**ZONING AMENDMENT
& SUBDIVISION STAFF REPORT**

Date: June 5, 2008

<u>APPLICANT NAME</u>	Amity Missionary Baptist Church
<u>SUBDIVISION NAME</u>	Amity Missionary Baptist Church Subdivision
<u>LOCATION</u>	South side of St. Stephen's Road, extending from Strange Avenue to Como Street, and Southwest corner of St. Stephen's Road and Como Street
<u>CITY COUNCIL DISTRICT</u>	District 1
<u>PRESENT ZONING</u>	R-1, Single-Family Residential, and B-2, Neighborhood Business Districts
<u>PROPOSED ZONING</u>	B-2, Neighborhood Business District
<u>AREA OF PROPERTY</u>	2 Lots / 1.2 ± Acres
<u>CONTEMPLATED USE</u>	Subdivision approval to create 2 lots, and Zoning approval to rezone the site from R-1, Single-Family Residential, and B-2, Neighborhood Business, to B-2, Neighborhood Business to eliminate split zoning for a proposed church. It should be noted, however, that any use permitted in the proposed district would be allowed at this location if the zoning is changed. Furthermore, the Planning Commission may consider zoning classifications other than that sought by the applicant for this property.

SITE PLAN

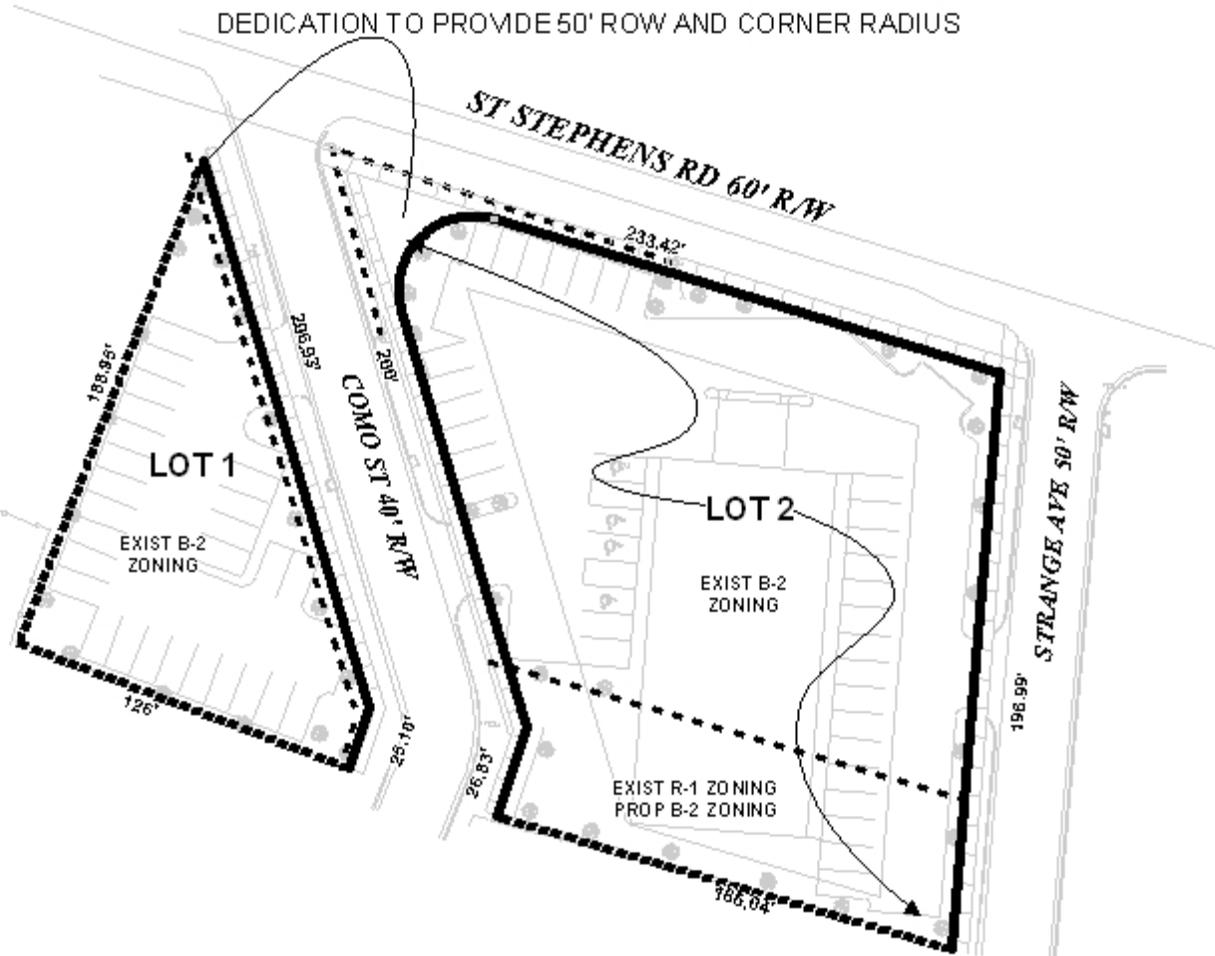
Driveway number, size, location, and design to be approved by Traffic Engineering and conform to AASHTO standards. Final approval for all driveways, proposed and existing will be given upon submittal of final plans. To eliminate conflicts in the parking areas some parking spots need to be removed or relocated. In the western lot the two spaces on the north side of the lot should be removed as well as the one parking space on the southeast end of the lot. In the east lot remove two spaces on the northwest end of the aisle located at the drive to eliminate conflicts with the driveway. Parking spaces located on the west side of the building on the south end of the aisle do not have adequate aisle width. Minimum aisle width is twenty-four feet. Changes should be made to accommodate the standard.

As St. Stephen's Road is a proposed major street, with a fairly narrow right-of-way, and as the site abuts two minor streets that primarily serve existing residences, access management is a concern. The applicant is proposing one curb-cut for proposed Lot 1 onto Como Street, and one curb-cut for Lot 2 onto Como Street and one curb-cut onto Strange Avenue. No curb-cuts are proposed onto St. Stephen's Road. Traffic Engineering has reviewed the site plan provided with the application, and has concerns regarding the layout of the parking area. As an application for Planned Unit Development will be required, a revised site plan should be prepared reflecting the comments provided by Traffic Engineering.

The site will abut residential zones to the South, thus a vegetative buffer or fence in compliance with Section 64-4.D.1. of the Zoning Ordinance will be required. The site plan should be modified to reflect either a fence or 10-foot wide vegetative buffer.

It should also be pointed out that some of the required landscape and frontage trees are placed in what could be the future right-of-way of Como Street, should a 50-foot wide right-of-way be required.

The revised site plans and plat reflect nearly all of the requirements with the exception of the minimum building setback line and lot size area. The site plans and plat should be revised to depict and label the 25-foot minimum building setback line from all street frontages, and to label the size of each lot in square feet.

Regarding the tree and landscape requirements, the site plan should be revised to show calculations for the requirements for each lot separately. This condition should be required for the PUD site plan.

Finally, if a dumpster will be provided for the church, it should be depicted on the site plan. This condition should be required for the PUD site plan.

- 2) Revision of the site plan for the Zoning application to reflect Traffic Engineering comments (*To eliminate conflicts in the parking areas some parking spots need to be removed or relocated. In the western lot the two spaces on the north side of the lot should be removed as well as the one parking space on the southeast end of the lot. In the east lot remove two spaces on the northwest end of the aisle located at the drive to eliminate conflicts with the driveway. Parking spaces located on the west side of the building on the south end of the aisle do not have adequate aisle width. Minimum aisle width is twenty-four feet. Changes should be made to accommodate the standard.*);

- 3) Revision of the site plan to reflect dedication along Como Street sufficient to provide a City-standard sidewalk along the West side, as well as the corner radius for the Southeast corner of Como Street and St. Stephen's Road that complies with Section V.D.6. of the Subdivision Regulations;

- 4) Revision of the site plan to depict and label the minimum building setback line from all streets, modifying the setback line along Como Street to accommodate a possible 50-foot wide right-of-way;

- 5) Revision of the site plan to depict a sidewalk along the West side of Como Street;
- 6) Revision of landscape area calculations to reflect changes in the size of the site due to right-of-way dedication; and

- 7) Revision of the site plan to depict and label a buffer that complies with Section 64-4.D.1. of the Zoning Ordinance, where the site abuts residentially zoned property.
